Our Ref: 22032

28 March 2022

**RE: 45 MOBBS LANE, CARLINGFORD
ASSESSMENT OF DRIVEWAY ISSUES**

Filename: 22032CAD002-220314-SIGHT_DISTANCE.dwg Date: 14 March 2022

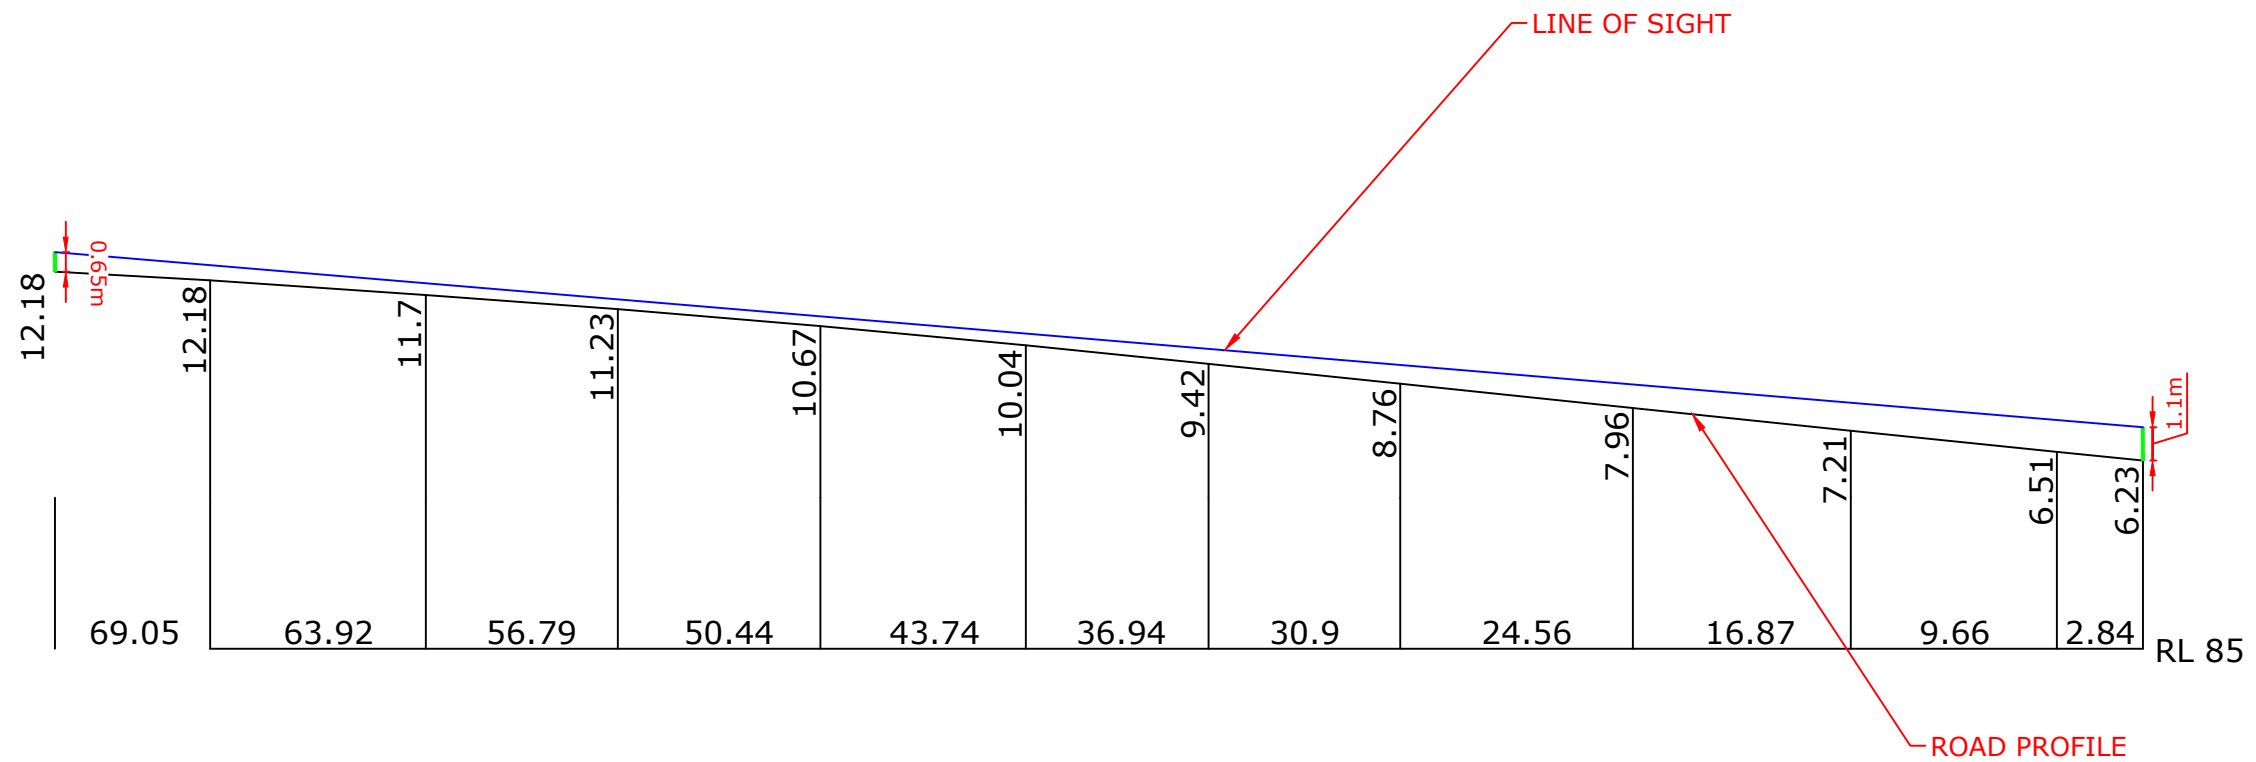
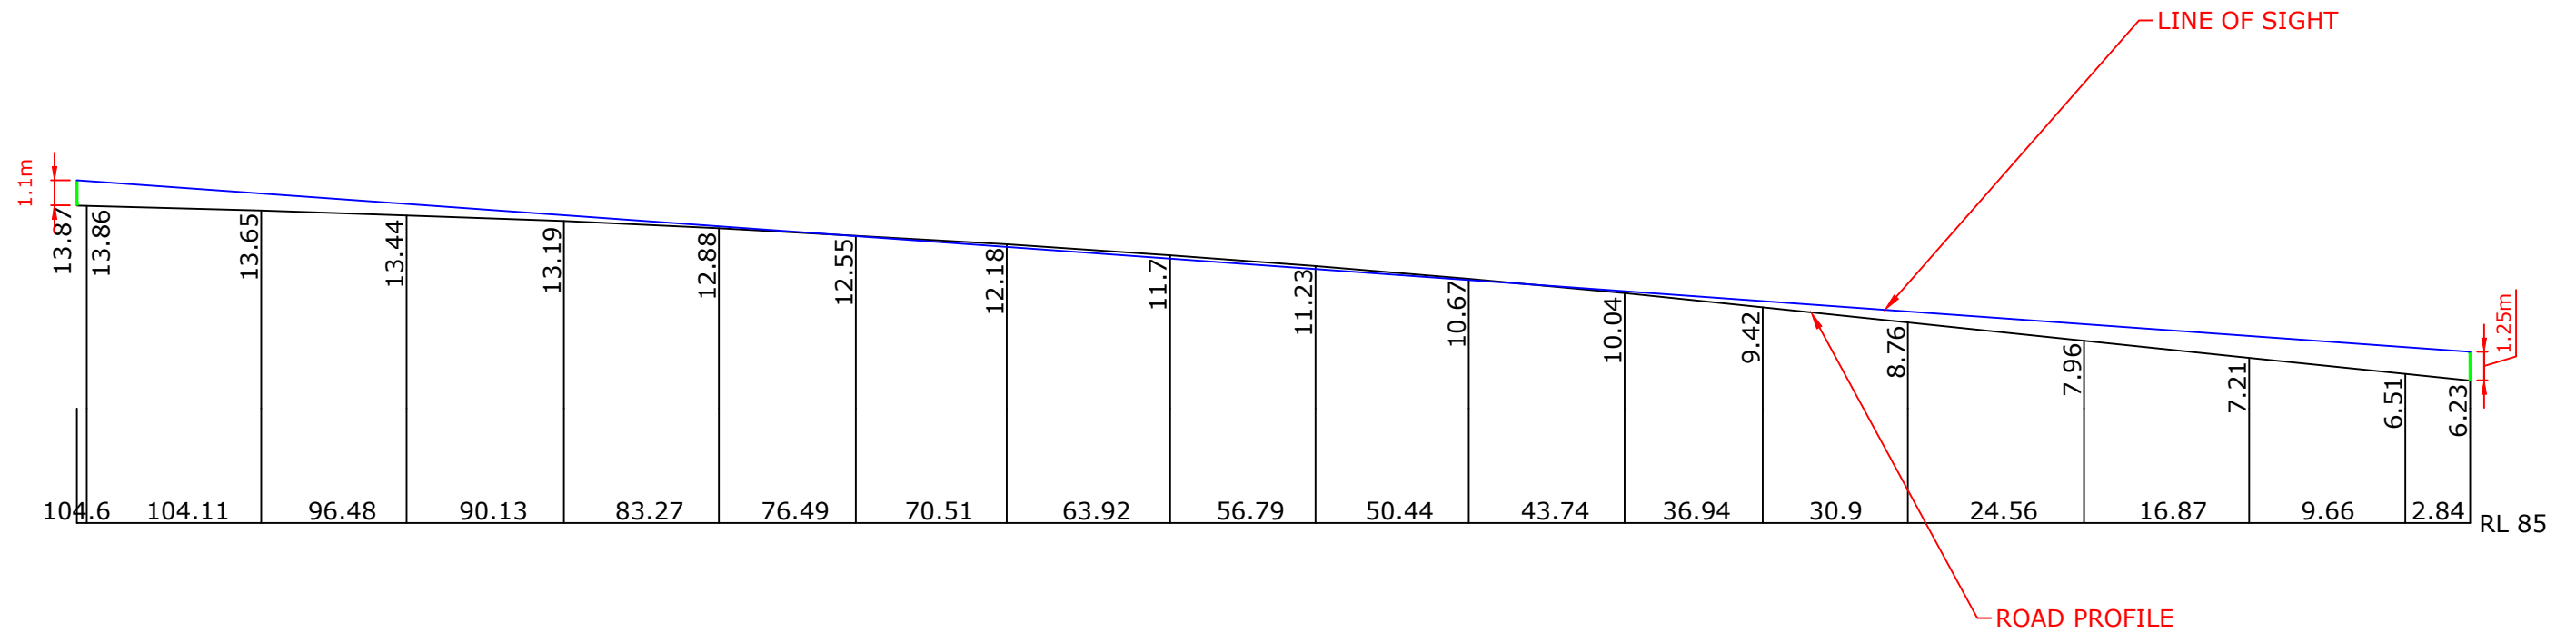
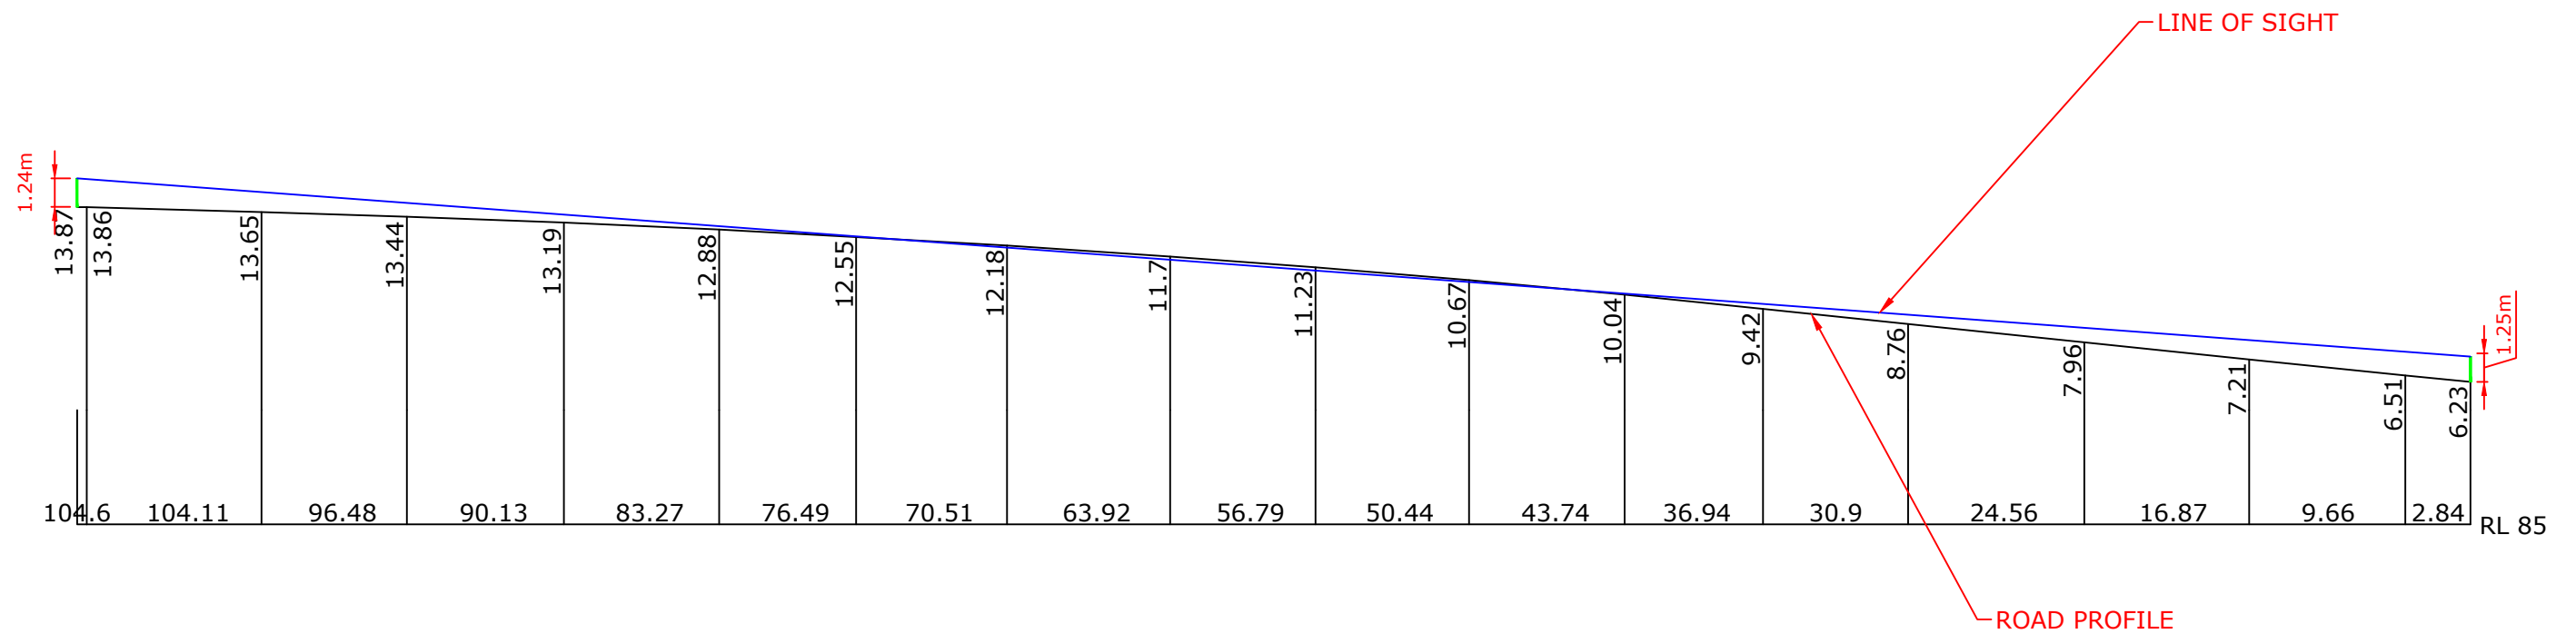
The analysis of these sight distances, contained at **Annexure B** confirms that the available AS2890.1 driveway sight distance and MGSD can be adequately provided but the SISD is marginally compromised by the profile of the road.
